工程指示 / 要求簡箋(E.I.)

工程指示編號：EI / 3187 / 21 修改版次：-
 工程編號：J - 852 工程名稱：亞皆老街中電
 工程項目：佛沙窗 師父板 (4th)
 收件人：生統 / 王良 發件人：Ant Yeung 日期：22/03/2021

To : Gammon Engineering & Construction Co., Ltd Ref no : 1980045.1-SM-50003-00
Attn : Mr. Dick Yuen / Mr. Jackson Mok Date : 9 September 2020
From : Ms. Cosimo Wong / Mr. Neo Wong Required Reply Date: 14 days
Project : Proposed Residential Development at 139 – 147 Argyle Street, Kowloon
Subject : Façade Works – Site Inspection Report #6

Site Inspection Report # 06

Photo #9

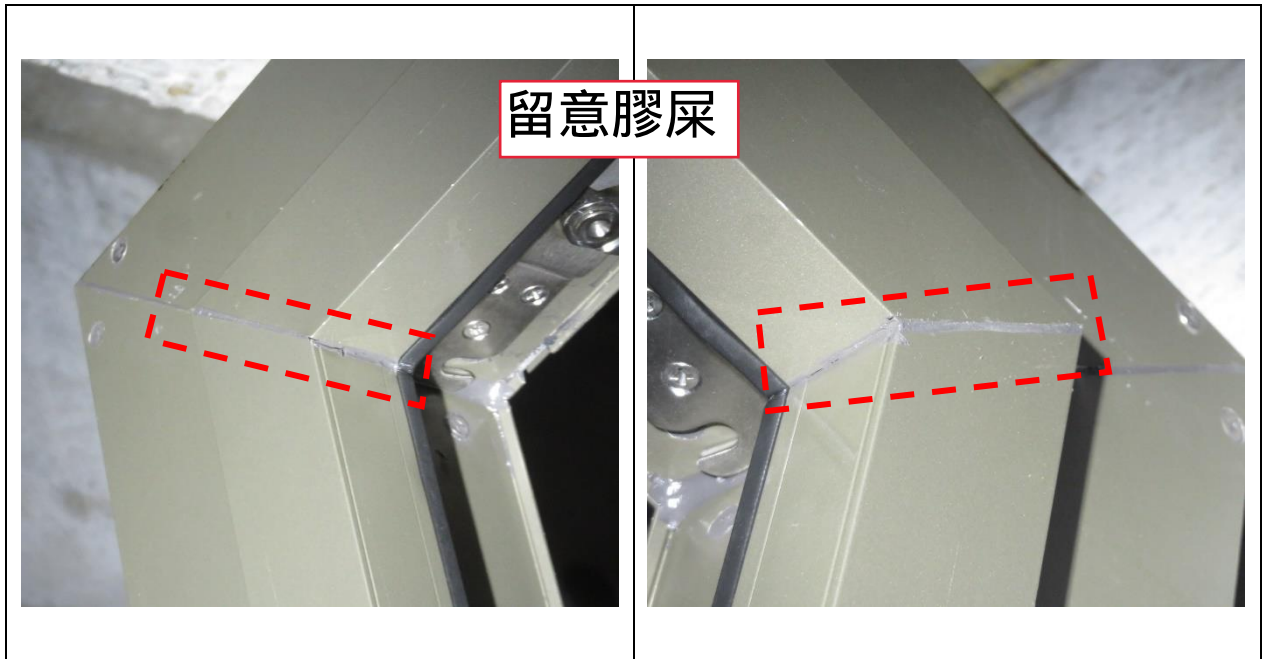
Observation (Window Frame)	Sealant was applied to the tight joints at window frame and sash. However, untidy sealant joints were observed.
Recommendation	Rectification work was carried out with reference to MFT's report 1980045.1MFHK-FI-RPT-002-00 Photo #13. Workmanship for sealant application should be improved.

Observation (Window Frame)	A severe damage was noted on the coated surface.
Recommendation	No rectification work was carried out with reference to MFT's report 1980045.1MFHK-FI-RPT-002-00 Photo #14.

Observation (Window Frame)	Re-application of bitumen paint to the area which to be in contact with precast concrete was noted.
Recommendation	Rectification work was carried out with reference to MFT's report 1980045.1MFHK-FI-RPT-002-00 Photo #15. It is further reminded to improve the workmanship of applying bitumen paint in factory.

Photo #12

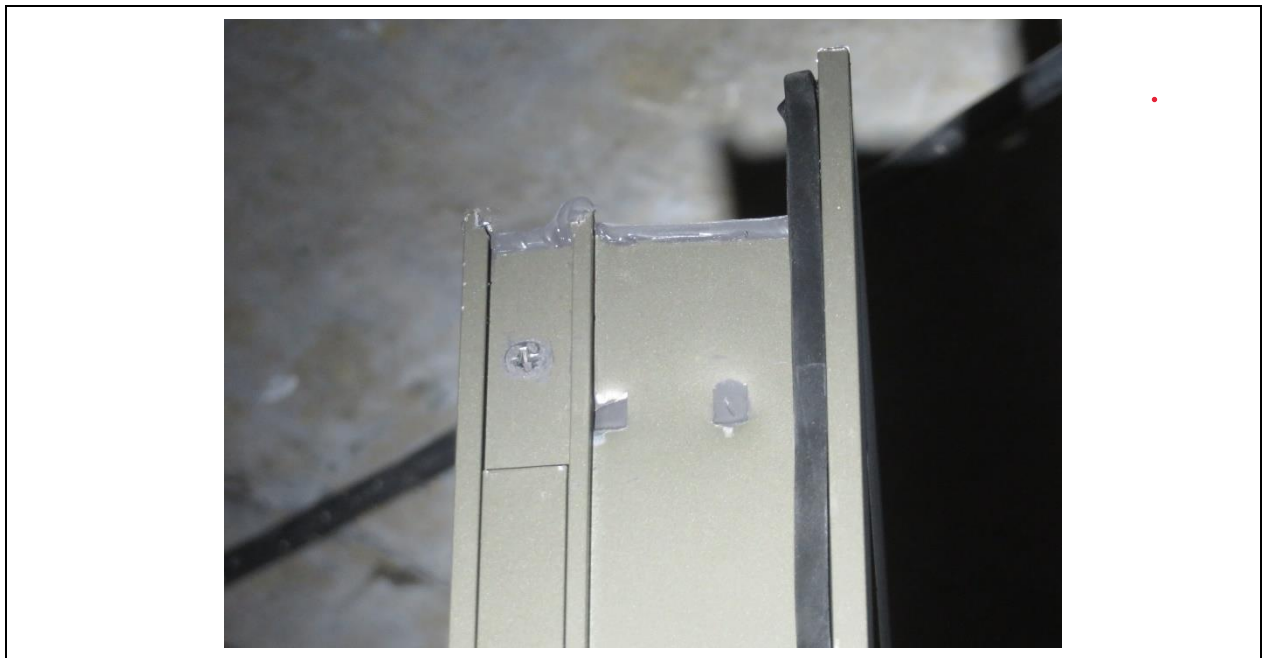
Observation (Window Sash)	Excessive sealant on the corner of a sash was removed.
Recommendation	Rectification work was carried out with reference to MFT's report 1980045.1MFHK-FI-RPT-002-00 Photo #16.

Photo #13

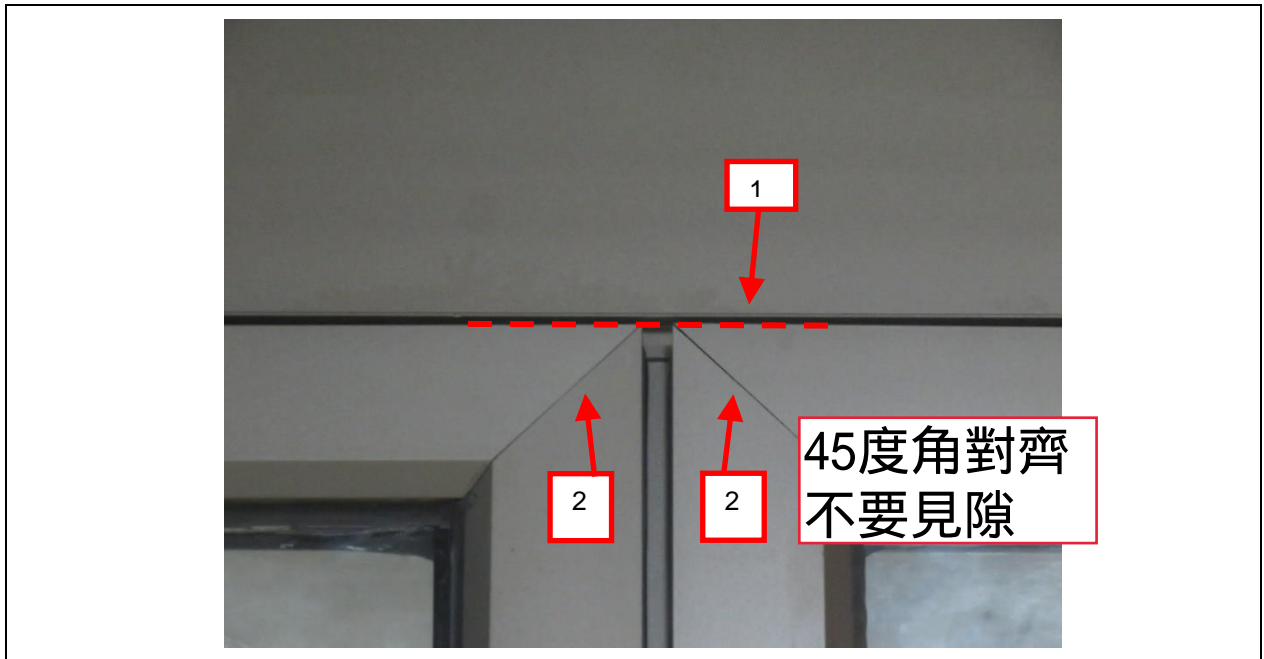
Observation (Window Sash)	1) Alignment between sashes was adjusted. 2) Uneven mitre joints could still be observed.
Recommendation	Rectification work was carried out with reference to MFT's report 1980045.1MFHK-FI-RPT-002-00 Photo #17. It is further reminded to improve the quality of fabrication as well as assembly in factory.

Photo #14

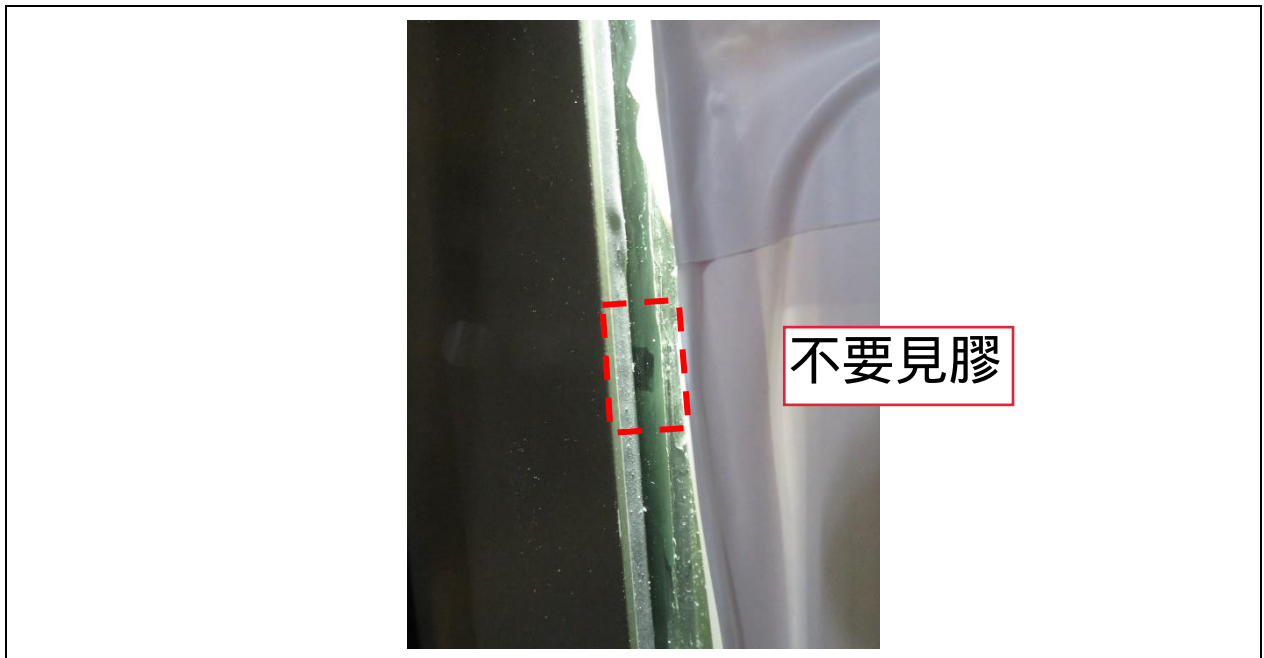
Observation (Glass Barrier)	Some spacers in the sealant joint around barrier glass were noticeable.
Recommendation	No rectification work was carried out with reference to MFT's report 1980045.1MFHK-FI-RPT-002-00 Photo #20.

Observation (Glass Barrier)	Poor workmanship was observed at a location of sealant joint.
Recommendation	No rectification work was carried out with reference to MFT's report 1980045.1MFHK-FI-RPT-002-00 Photo #21.

Photo #16

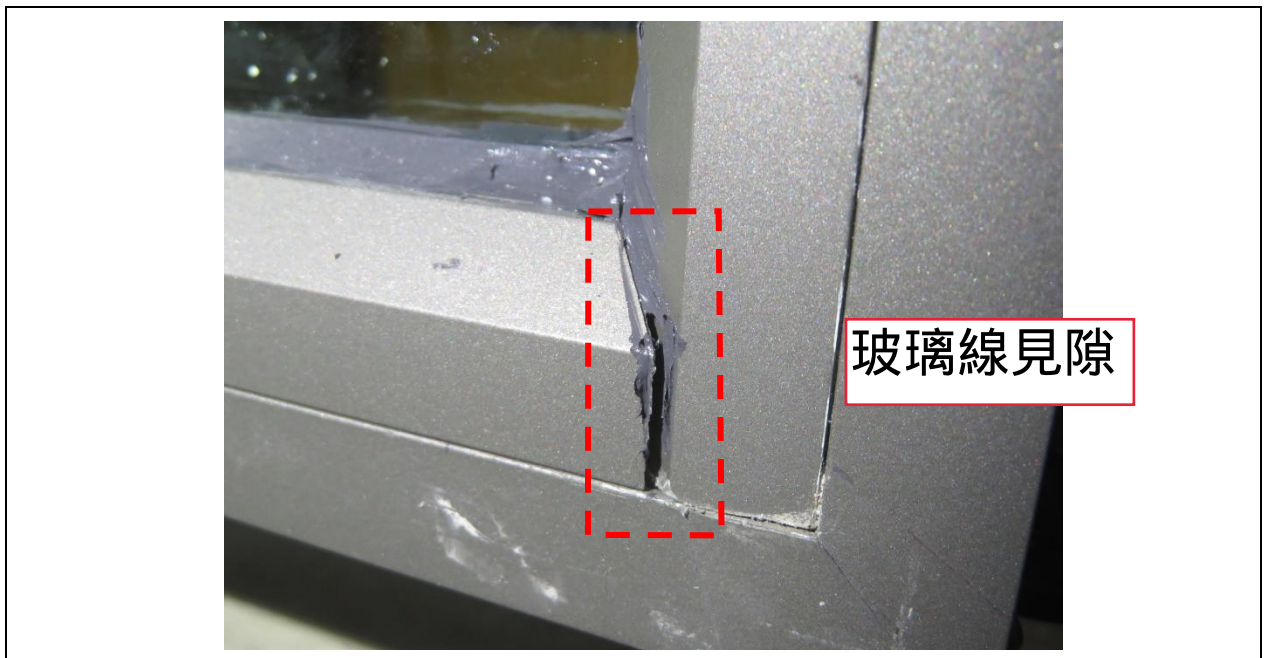
Observation (Window Sash)	Noticeable gap between glazing bead covers of sashes were observed.
Recommendation	Improvement in quality of fabrication as well as assembly is recommended.

Photo #17

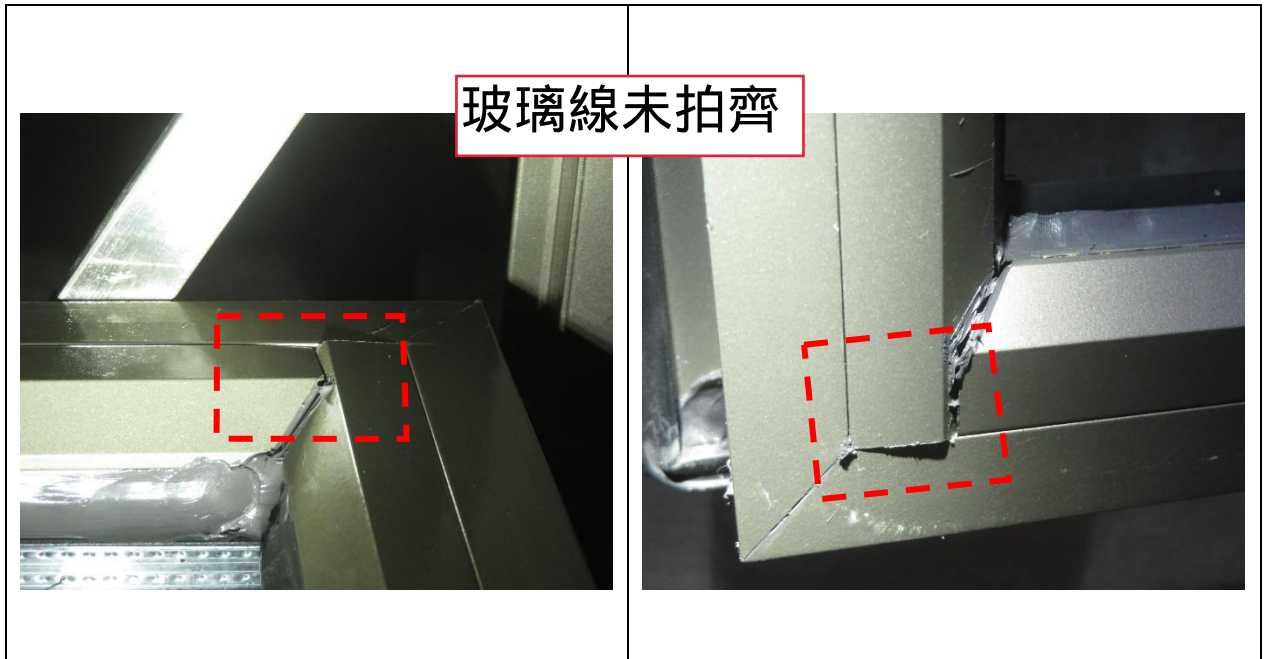
Observation (Window Sash)	Surfaces between glazing bead covers were not flush.
Recommendation	Rectification is required.

Photo #18

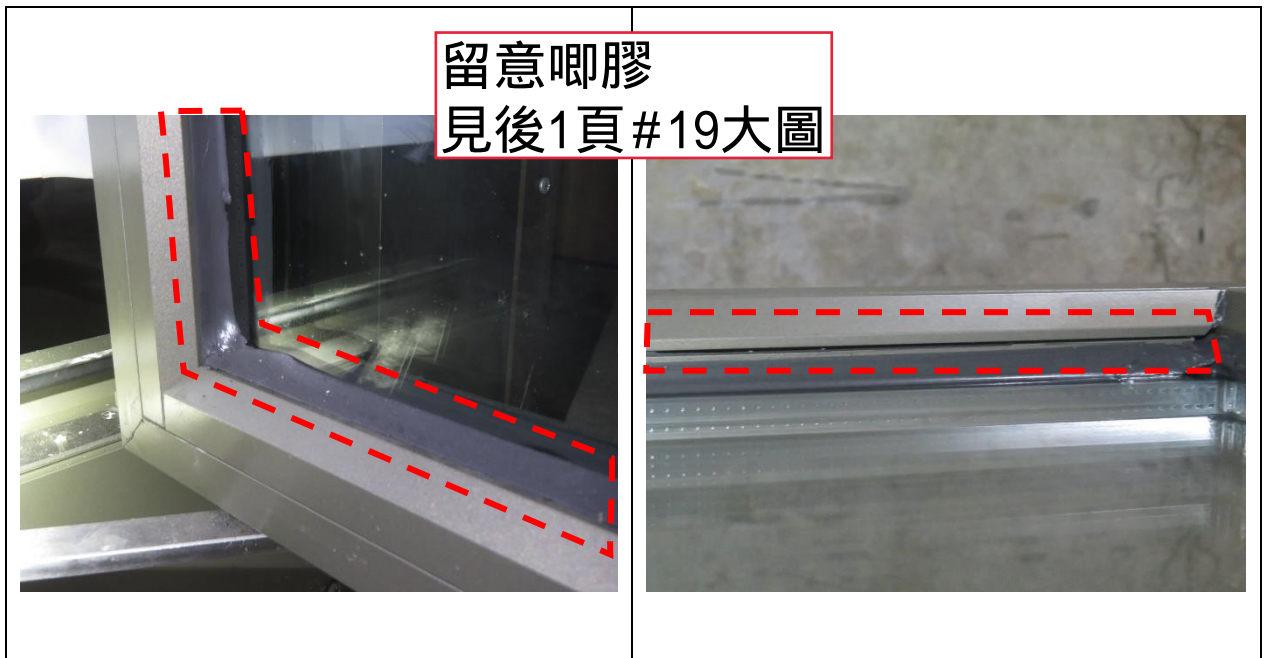
Observation (Window Sash)	Inconsistent glazing sealant of sashes (i.e. gaps between glazing beads and glazing bead covers were filled with sealant (LHS) or without sealant (RHS)). Please refer to Photo #19 for shop drawing detail.
Recommendation	Midi to clarify the inconsistency found. Rectification is required as per latest shop drawing.

Photo #19

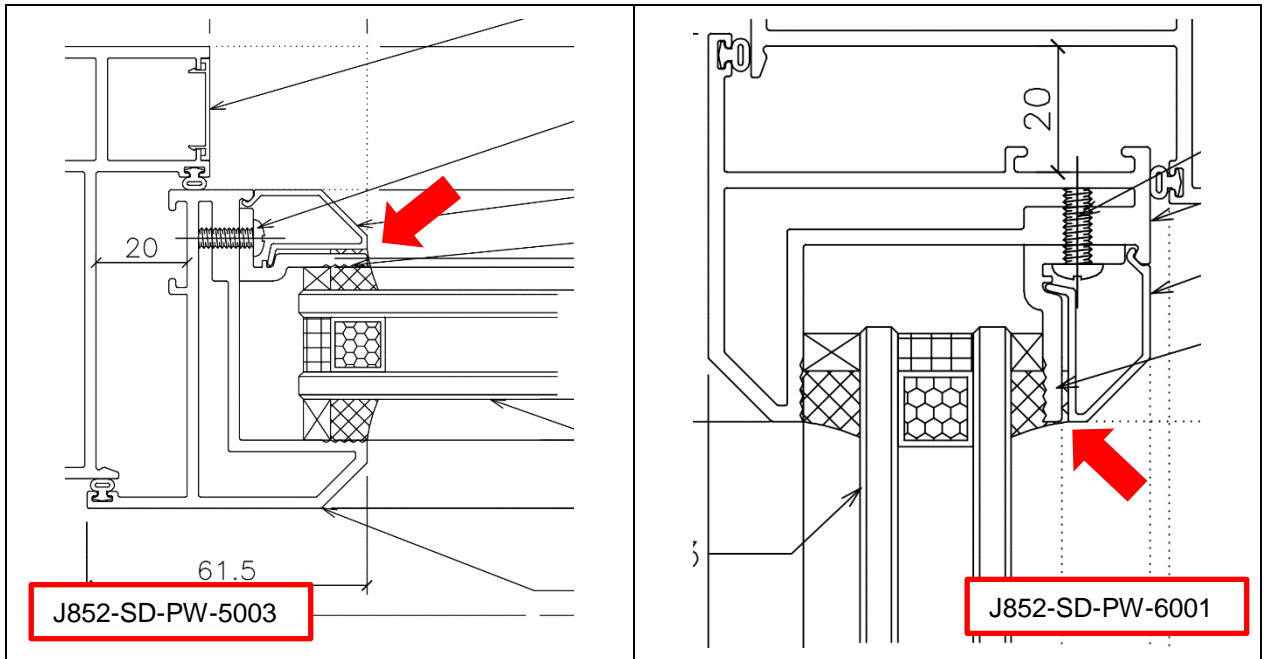
Observation	The above detail is extracted from latest shop drawings no. J852-SD-PW-5003 and J853-SD-PW-6001, sealant should be applied for the gap between glazing bead and its cover.
Recommendation	-

Photo #20

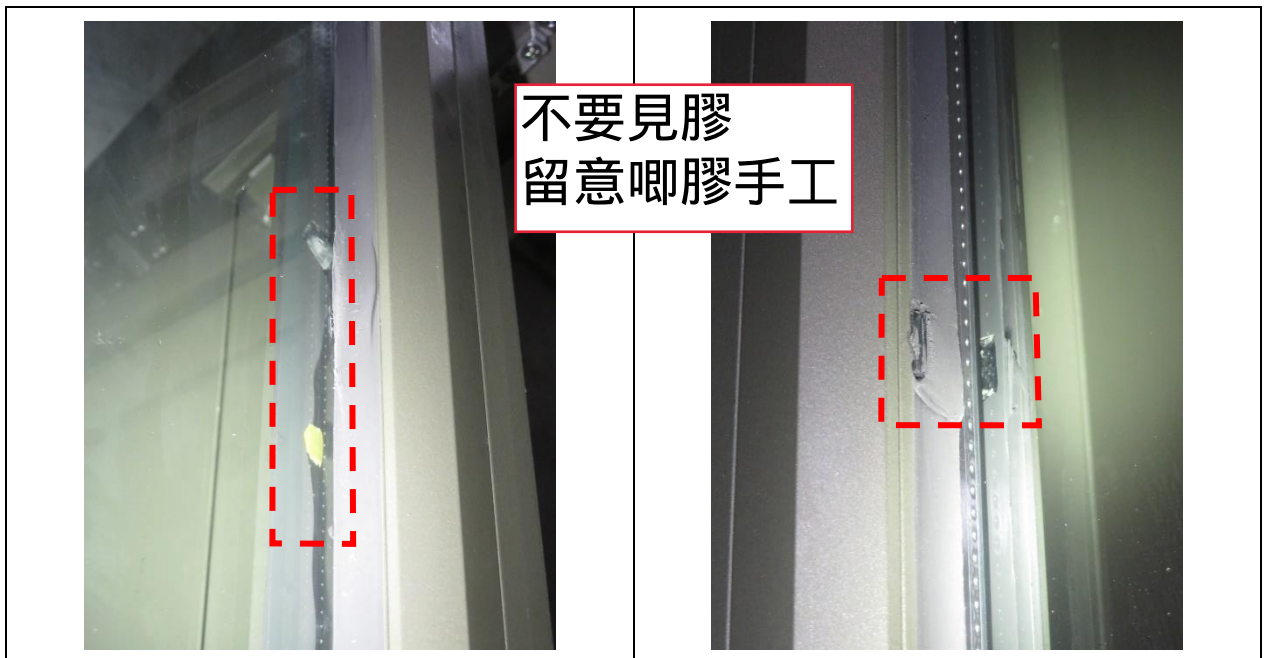
Observation (Window Sash)	Some spacers in the glazing sealant of sashes were noticeable.
Recommendation	Rectification is required.

Photo #21

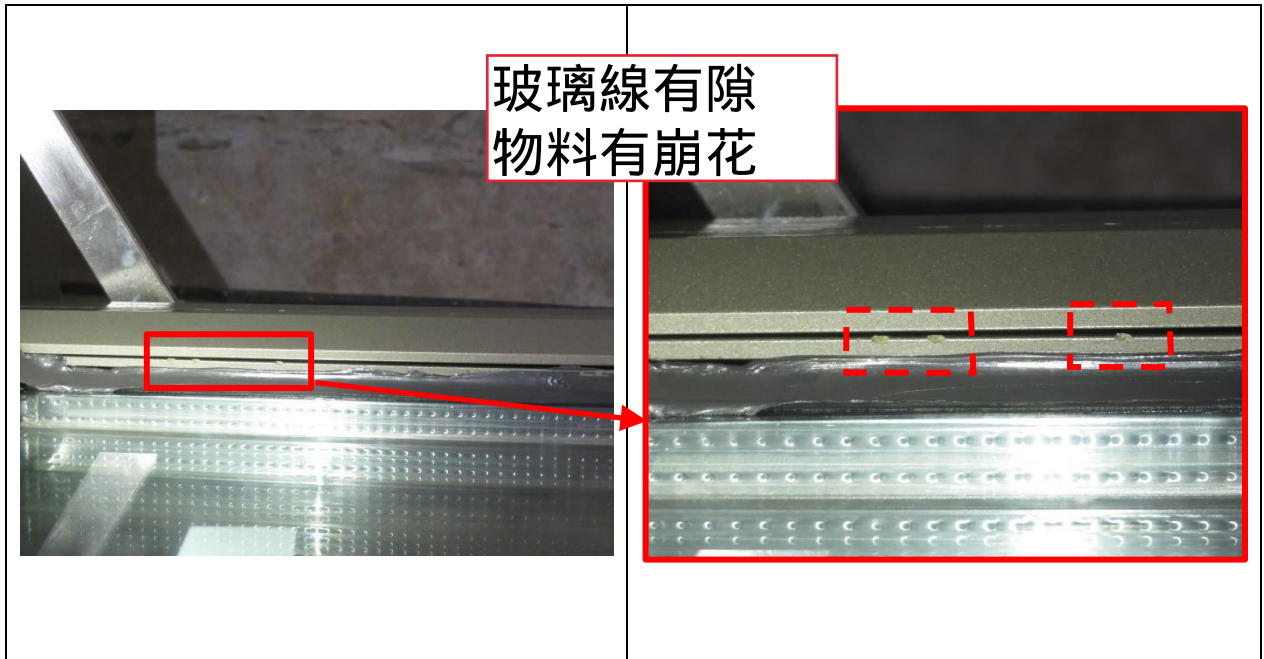
Observation (Window Sash)	LHS: Significant gap between glazing bead and glazing bead cover was noted. RHS: Damages were observed on the edge of glazing bead.
Recommendation	Please refer to Photo #16 for comment. Review of protection and handling of material are recommended.

Photo #22

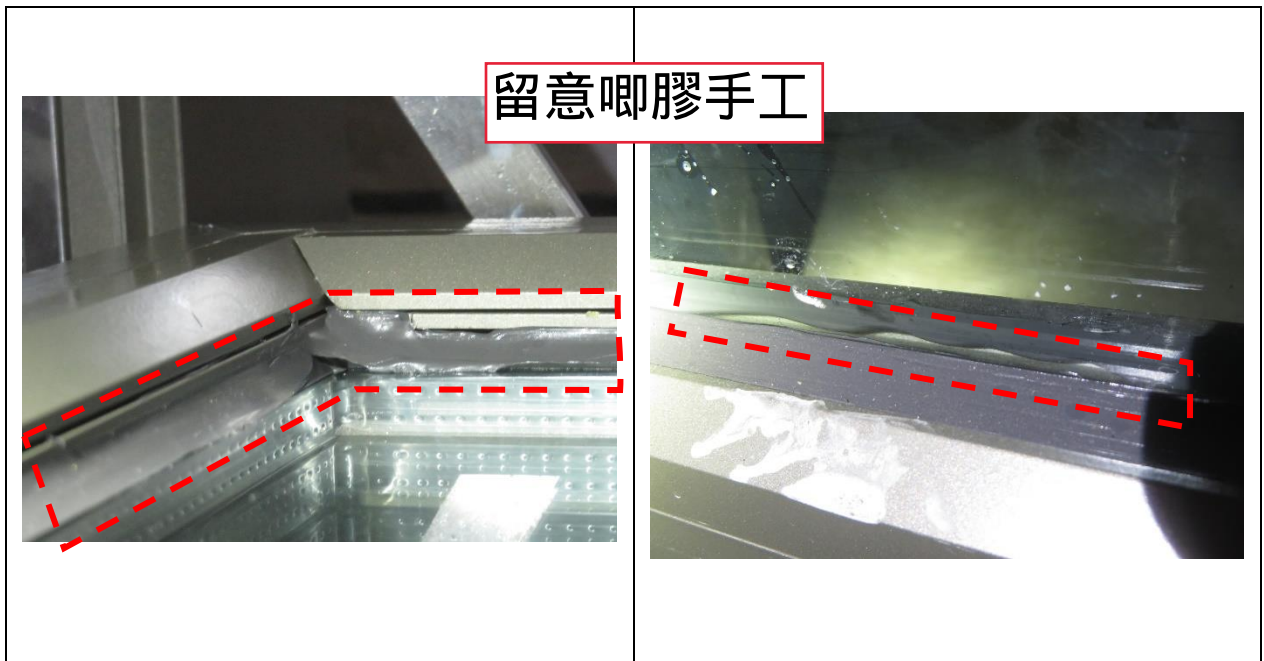
Observation (Window Sash)	Poor workmanship of glazing sealant was generally observed.
Recommendation	Rectification is required. Workmanship for sealant application should be improved.

Photo #23

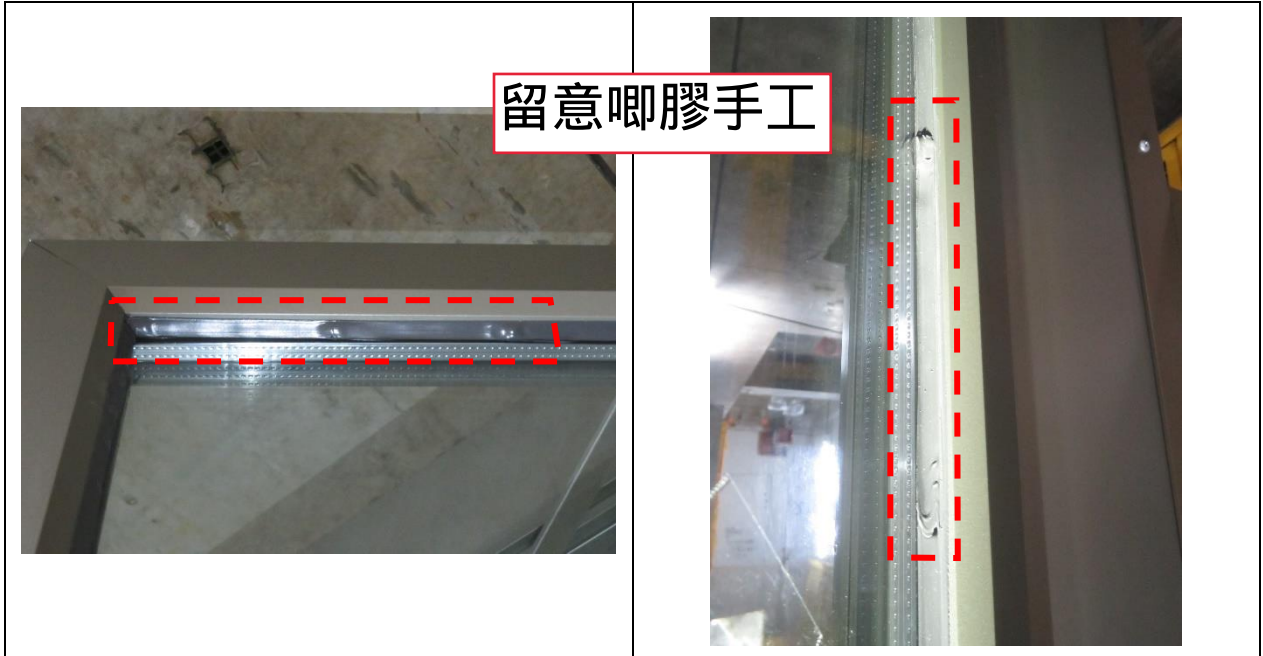
Observation (Window Sash)	Ditto.
Recommendation	Ditto.

Observation (Window Sash)	Pulling force required to close the window sash was around 5kg – 6.5kg (i.e. around 49N – 64N).
Recommendation	-
